RE: ENERGY STAR for Exterior and Interior Storm Panels
12/30/16 Response by Doug Anderson to AAMA letter of 12/19/16

Evidence of Safety Concerns

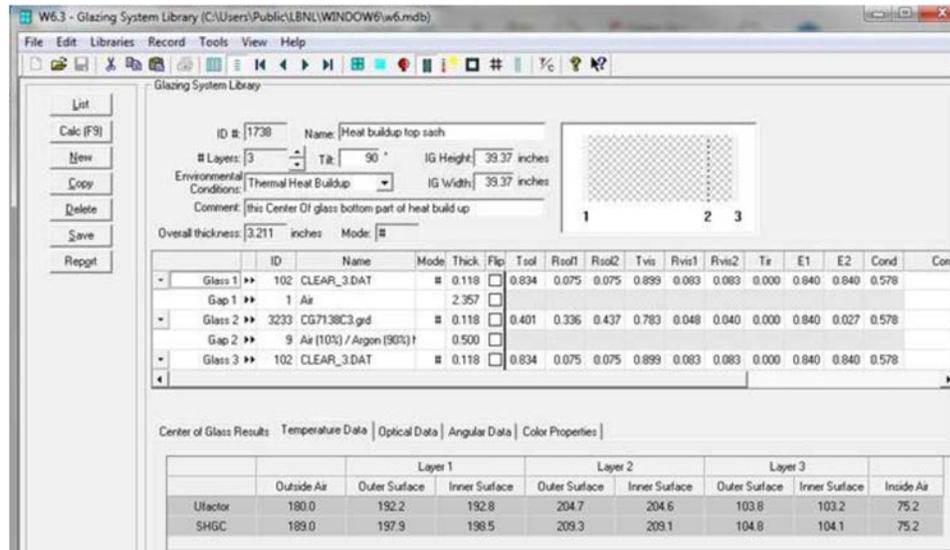
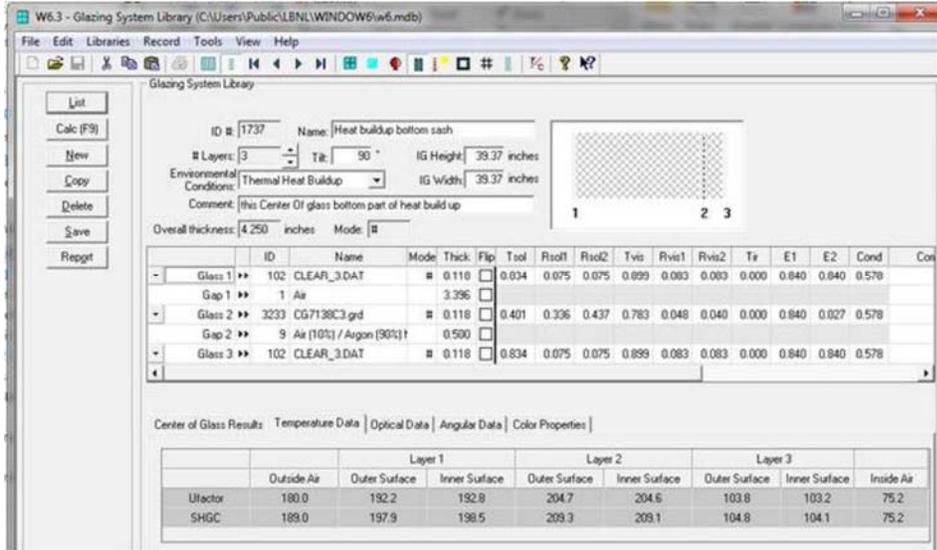
WINDOW 6.3 was used to simulate a theoretical triple pane unit matching the glass spacing and glass makeup of an example common prime window with storm product attached on the outside. The below shown screen shots are the two different calculations that would represent the top sash and bottom sash for more accuracy in a common double hung configuration.

A physical test was performed in the lab. The values used for the simulation are based on actual numbers from that physical test, as shown in the screenshots below. A standard ASTM black plate was used to control the infrared to S. West USA conditions at 180 degree F maximum solar. Outside air is the temperature of the surface of the storm window. Layer 1 is the storm glass, Layer 2 is the outside glass of the window IG's, and Layer 3 is the inner glass panel of the IG. Inside air is the temperature of the test lab where the physical test was performed.

The simulation was kept simple so anyone can easily duplicate the output using WINDOW 6.3 software. The estimates and calculations are conservative due to the simple tools representing glass temperature. Note that a solar absorbing dark colored non-spectral surface will have a higher temperature than the 204.6 degrees F shown.

These results stress the importance of considering heat as a cause of potential glass breakage in prime windows when after-market storm products are installed.
